Subject: NRC Request for Additional Information – November 27, 2012

**Response to NRC Request for Additional Information
Dated November 27, 2012**

**CE Windsor Site
Windsor, Connecticut**

**NRC License Number 06-00217-06
Docket Number 030-03754
Control Number 577155**

Figure 1 – Systematic and Investigation Samples for CE-FSS-33-09

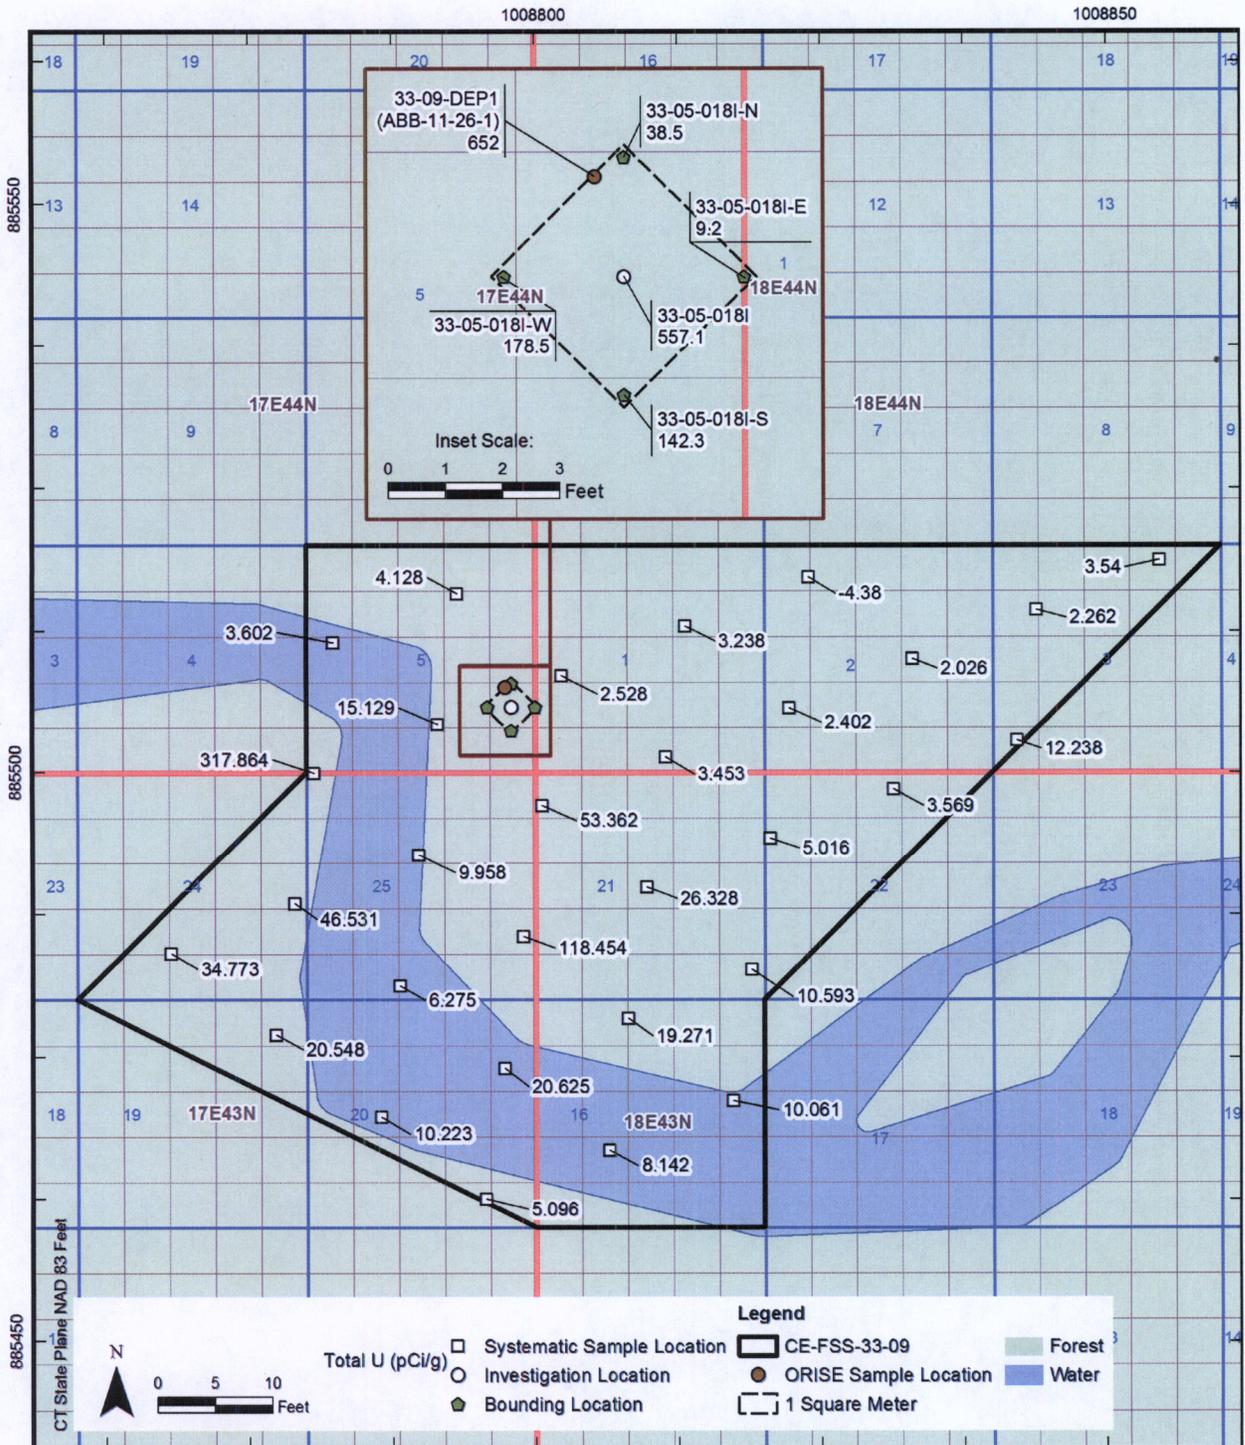
Final Status Survey Report Submittal (FSSRS) No.5, volume I, section 3.2.10, references survey unit CE-FSS-33-09. This Class 1 survey unit is associated with the Site Brook. Inspectors from the Nuclear Regulatory Commission (NRC) and the Connecticut Department of Energy and Environmental Protection (CTDEEP) were on site on October 7, 2011, and collected biased confirmatory soil samples from this survey unit. Samples were split with ABB, NRC, and CTDEEP. The NRC samples were sent to Oak Ridge Institute for Science and Education (ORISE) for analysis. A report from ORISE, dated November 1, 2011, with the results for the soil samples collected from this survey unit, sample ABB-11-26-1 indicated a result for total uranium of 652 pCi/g. This exceeds the site specific DCGL for total uranium of 557 pCi/g. The CTDEEP sample number for this is FSS-33-09-DEP-1. A copy of this ORISE report was forwarded to ABB, Inc. and CTDEEP via an email dated November 2, 2011. There is no mention of this sample in section 3.2.10 of FSSRS No.5. Please describe what follow-up action was taken as a result of the site specific DCGL for total uranium being exceeded for sample ABB-11-26-1.

Gamma walkover survey data from survey unit 33-05, an area (Grid 17E44N-5) was identified for further investigation (elevated reading of 35,220 cpm gross) that had been surveyed using an unshielded 5" by 2" NaI detector in a water-tight housing. To prepare the area for investigation (rescan) with a 2" by 2" NaI detector system, the area was sand-bagged and dewatered. Since the 2" by 2" NaI gross gamma scan measurement values for the rescanned grid exceeded the investigation limits, a biased investigation sample (FSS-33-05-018I) was obtained at location 17E44N-5-E2. Pre (4,743 cpm) and post (3,262 cpm) sample static NaI gross gamma results were annotated on the investigation walkover scan survey (Appendix F page 20). Because the investigation sample gamma spectroscopy results exceeded the $DCGL_w$, an EMC investigation survey was performed to determine the extents of the elevated area. The methodology used for performing elevated area bounding investigation sampling is summarized in FSSRS No. 5, Section 2.7. Gamma walkover survey data gathered during the EMC investigation bounding survey with 2" x 2" NaI provided additional confidence that the initial investigation sample captured the source of the elevated measurement, as the maximum measurement of 3,600 cpm was less than the gross scan measurement investigation level of 4,004 cpm as listed in Table 2.7 of the FSSRS No. 5.

Because the elevated area was reclassified as new Class 1 FSS survey unit 33-09, the small EMC area was rescanned during the 100% gamma walkover survey of survey unit 33-09. No elevated measurements were identified during this gamma walkover scan. Again this corroborates the previous gamma walkover during the investigation that elevated readings were due to a small discrete anomaly and not a large area of the survey unit with elevated residual radioactivity. Additional confidence that the uranium anomaly was captured in the original investigation sample was provided by the one-minute post static NaI gamma results obtained after investigation sample acquisition, that indicated less than the gross investigation level, as documented on the investigation walkover scan survey cover sheet on page 22 of Appendix F of the Submittal 5 FSSR.

The systematic FSS samples collected as part of survey units 33-05 (17 samples) and 33-09 (30 samples) provided results that were well below DCGLs. This is further evidence that no large areas of elevated residual radioactivity were missed during remediation or FSS. Moreover, the location of the independent verification sample identified as ABB-11-26-1 (or FSS-33-09-DEP-1) was located within the EMC area. The locations and total uranium concentrations for survey unit 33-09 and the ABB investigation sample plus the independent verification sample are presented in Figure 1. Figure 1 also displays the variability of total uranium across this area and shows that the independent verification sample is within the 1 square meter EMC area around investigation sample 33-05-018I. Note that the EMC area bounding sample 33-05-18-N is next to ABB-11-26-1 and has a total uranium value of 38.5 pCi/g, once more demonstrating that the residual radioactivity in this area is discrete anomalies.
